City of Richmond

Report to Development Permit Panel

File: DP 15-703204

Re: Application by Matthew Cheng Architect Inc. for a Development Permit at
7751 Heather Street

PLAN#1

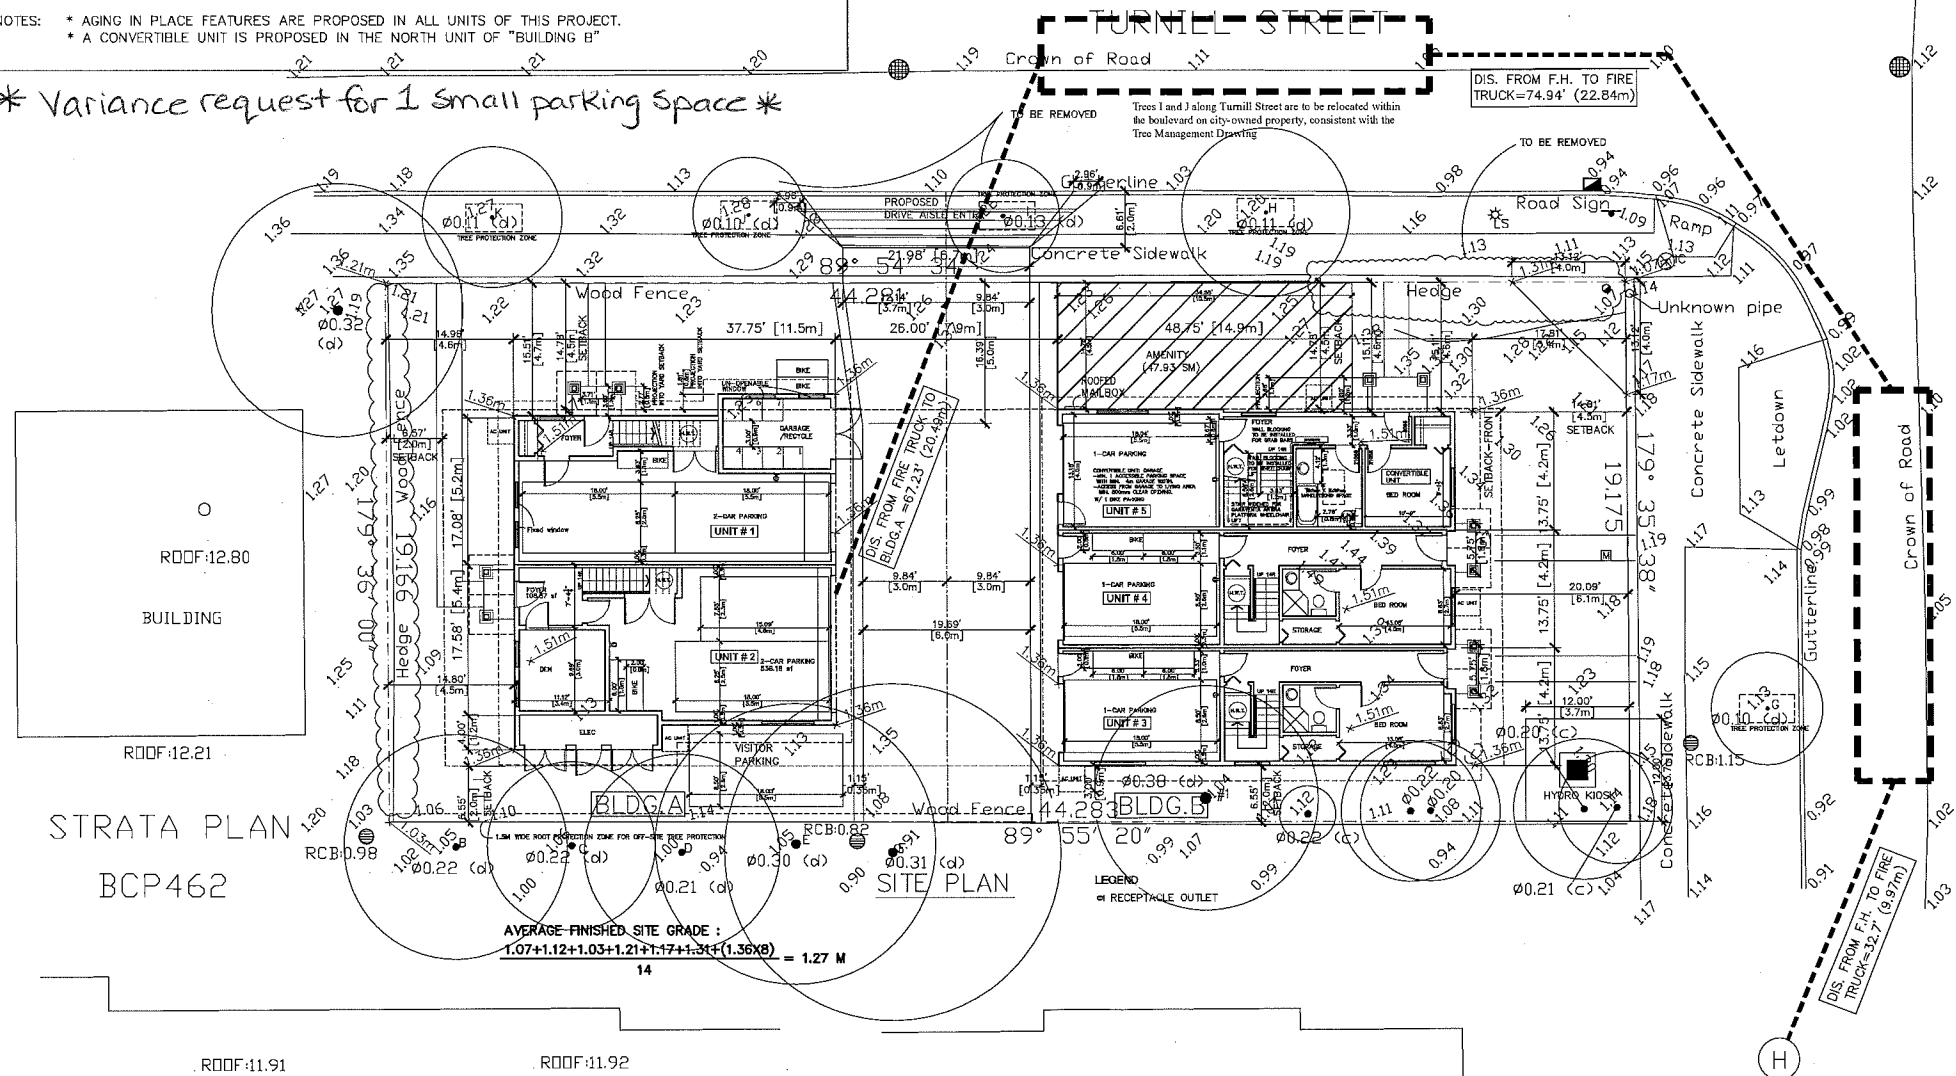
The parking provisions of the Zoning Bylaw do not permit small parking spaces unless the total on-site parking requirement is 31 or more spaces. The variance request would enable the proposed parking for the south unit in the west building to be located in a side-by-side arrangement within the garage (Plan # 1).

- *The proposed number of resident parking spaces and visitor parking space on-site fully meets the Zoning Bylaw requirements (i.e., 1.4 spaces per unit). The proposal includes a total of seven (7) resident vehicle parking spaces and one (1) visitor parking space on-site. The three (3) units in the east building are proposed to each contain one (1) vehicle parking space in the garage; while the two (2) units in the west building are proposed to each contain two (2) vehicle parking spaces.*
- *By proposing a small parking space for one (1) of the required resident vehicle parking spaces in the garage of the southwest unit, it has reduced the number of parking spaces proposed in a tandem arrangement from four (4) to two (2), and avoids the need to relocate the surface visitor parking space to the exterior side yard where it would otherwise be exposed to public view.*

* Variance request for 1 small parking space *

PLAN # 3.a.

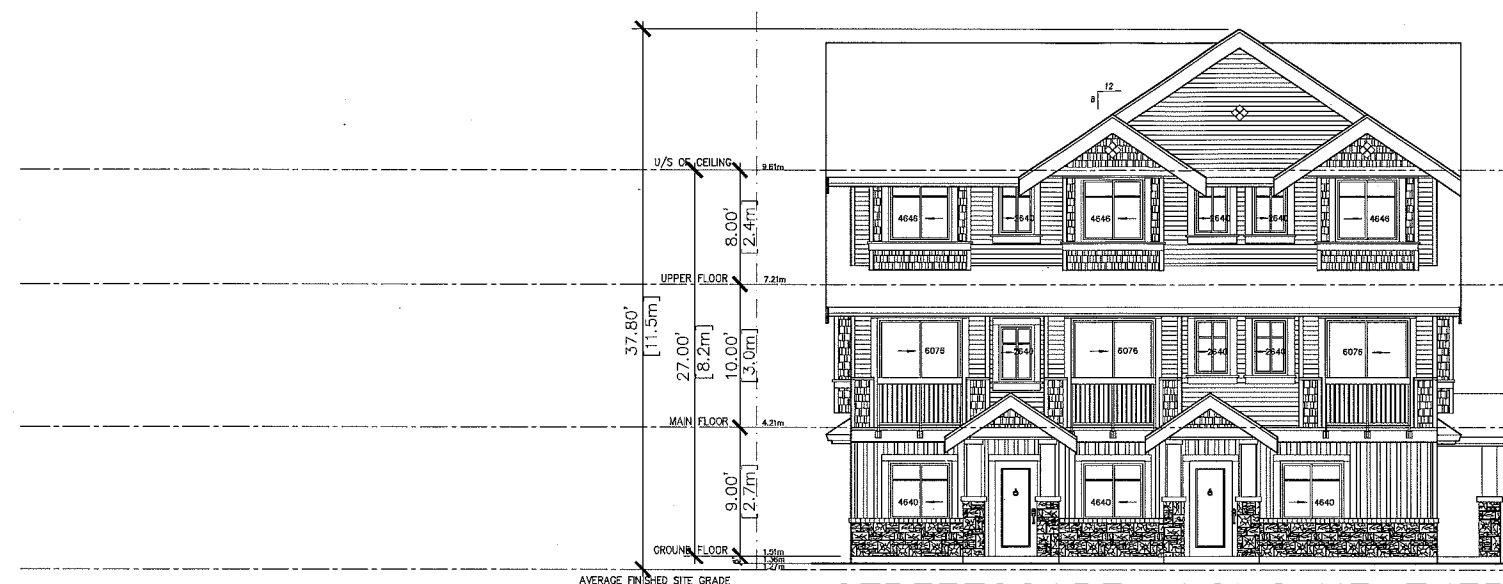
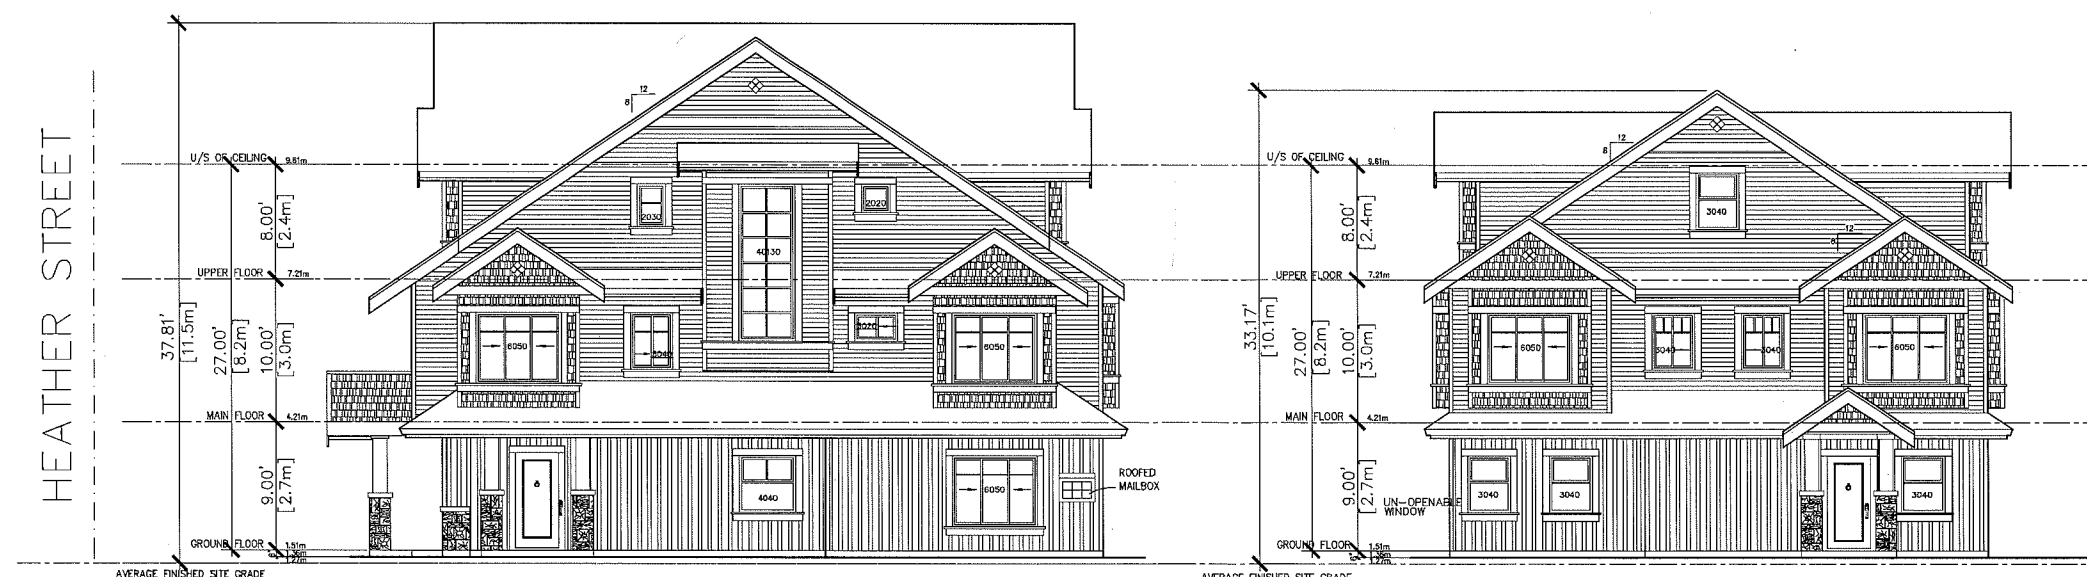
- Deeper pitched roof overhangs, re-emphasis of the roof pitch at the ground floor level, and the addition of a single large gable end closest to the intersection of Heather and Turnill Streets.

- Minor revisions to window types and sizes to draw attention away from the verticality of the bay elements along the Heather Street elevation.
 - A varied colour/material scheme.
